**U.S. ENVIRONMENTAL PROTECTION AGENCY  
REGION III  
CLEAN WATER ACT  
COMPLIANCE INSPECTION REPORT**

**Name of Site:** The Parks at Walter Reed  
**Site Address:** 6900 Georgia Avenue NW, Washington D.C., 20012  
**Mailing Address:** 6900 Georgia Avenue NW, Washington D.C., 20012

**Unique Project Identification (UPI):** 3E22WN073A

Figure 1. Overview of the entire site. The red line encompasses the approximate areas of the site under construction, most of which was disturbed, at the time of the inspection.

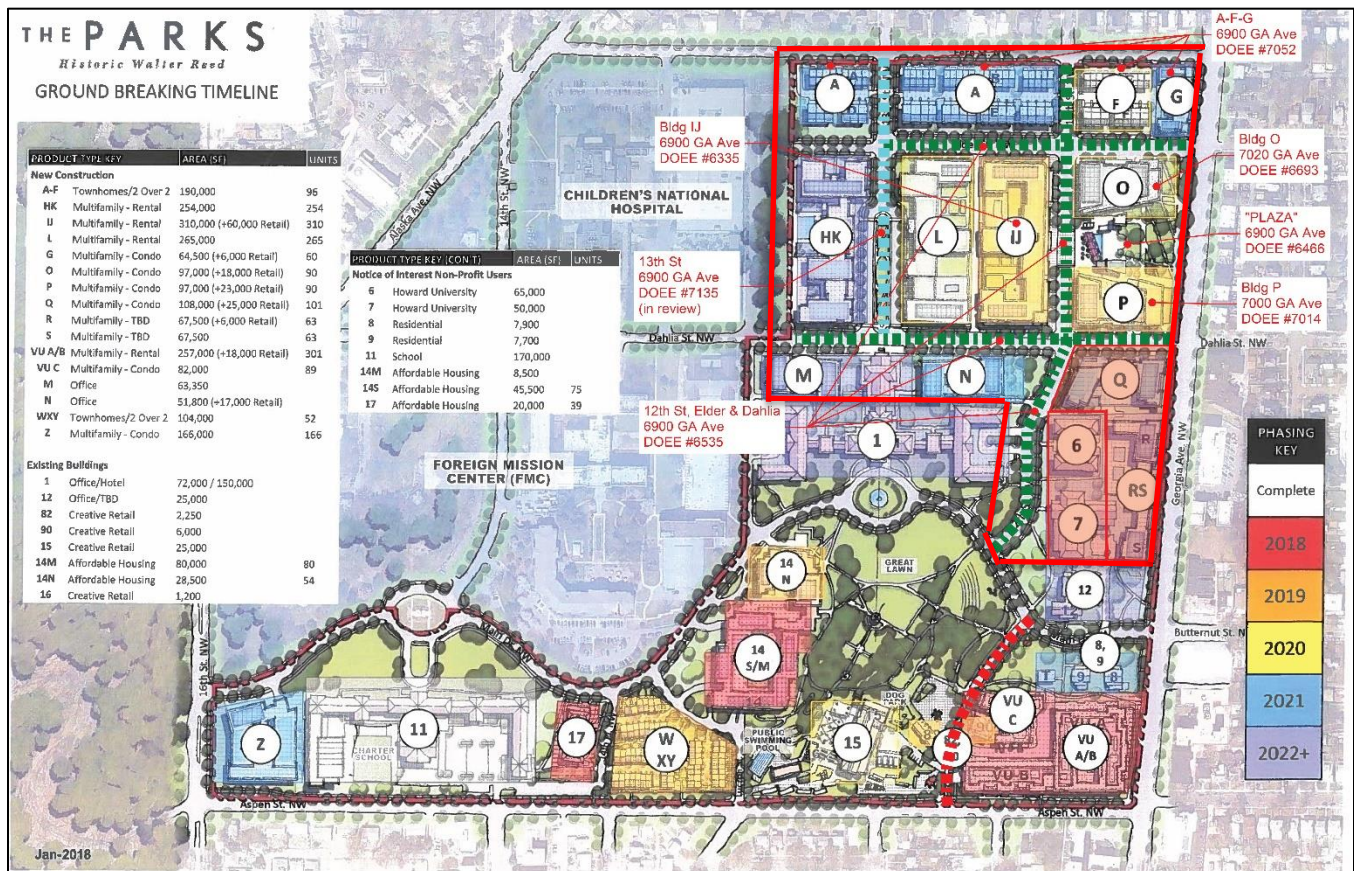
**Observation 8.** A storm drain inlet was observed in the area labeled “M” in Figure 1 that required maintenance. The inlet was protected by gravel and filter fabric but was covered with sediment (refer to [Appendix B, Photographs 22 and 23](#)). Site representatives stated that the storm drain inlet led a dewatering sump in the basement of the adjacent building that discharged to the storm sewer.

- Observation 14.** The EPA Inspection Team observed the site map included in the onsite SWPPP did not contain all Permit-required elements (refer to [Appendix C, Exhibit 7](#)). Additionally, several site engineering plans were reviewed during and after the inspection, which did not include all required elements (refer to Figure 1), including:

- Drainage patterns of stormwater before and after major grading activities.
  - Locations where all stormwater and authorized non-stormwater will be discharged to storm drain inlets. Specifically, the EPA Inspection Team observed one storm drain inlet in the south area of the property that was not identified on the site map (refer to [Appendix B, Photographs 22 and 23](#)).
